XT VANE RETROFIT

MAY 2017

REPLACE DRIVE SLEEVE 19

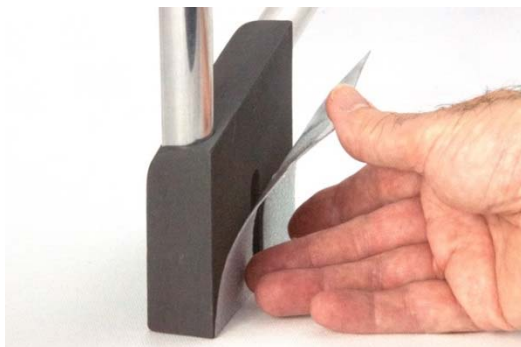
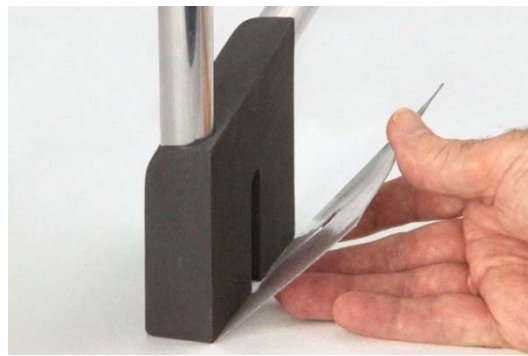
Vane Knob (#32) has been redesigned to eliminate two smaller, finicky parts: the Vane Slot Collar (#4) and Vane Slot Sleeve (#6). The Vane Bolt Set (#37) has also been changed to an M10 bolt set. The Pads are required to ensure the Vane can be secured in place.

3. **REMOVE OLD PARTS** - Remove Old Vane Knob (#32), Vane Slot Collar (#4), Vane Slot Sleeve (#6), and 3/8" Vane Bolt Set (#37). *You will not need to reuse these parts.*

4. **CUT OFF PROTUDRING PART OF VANE SLOT PEG (#5)**
 - Vane Slot Peg (#5) is the plastic peg that sticks out of the Vane Lever. Use the bevel side of a sharp chisel on the casting and wack with a mallet. You are not removing the Peg, just cutting the protruding part off. **DO NOT TRY TO BANG OUT THE PEG COMPLETELY** for fear of damaging something else.

5. **TAP HOLE FOR M10 BOLT** - Apply a small amount of lubricant to the 10mm Tap supplied and start it into the exposed thread using fingers. Check that it is entering the existing thread correctly and square to the surface. Use a tap wrench (preferably) or other similar tool to re-cut the thread to 10mm. Recently supplied units may not need this operation as the new 10mm bolt/new Vane Knob will already be in place. If you have not tapped a thread before, you may wish to get some assistance with this task.

6. **APPLY FILLER PLATE TO VANE LEVER RECESS AREA** - Remove backing paper from the Filler Plate and attach it to the recess on the flat side of the Vane Lever. Hold the Filler Plate clear and align the top edge, centering it on the sides of the gap. Lower it slowly checking that it will lay correctly in the gap, leaving the tapped hole clear and the plate edges not standing above the surrounding area. **NOTE:** This is a pressure sensitive adhesive. If you have not applied any force to the plate it may be possible to adjust the position by lifting it before the vane has been clamped to it.

7. **INSTALL NEW KNOB AND BOLT** - Enter the M10 Button Head Bolt into the new Vane Knob, from the hole on the large side. The Hex Key is required. Attach the knob/bolt both to the vane lever on the flat side (the side you just added the Filler Plate to). Add nut and washer on the other side without tightening. NOTE - the new bolt is inserted from the opposite side of the old one.

8. **ADJUST** - The underside of the bolt head should be almost flush with the vane base when the vane is clamped. The screw is in the correct position when the vane can be removed easily when the knob is fully rotated anticlockwise. Check that the knob will clamp both the new and older vane firmly in place. Once correct, firmly tighten the locking nut while holding the screw with a Hex Key.
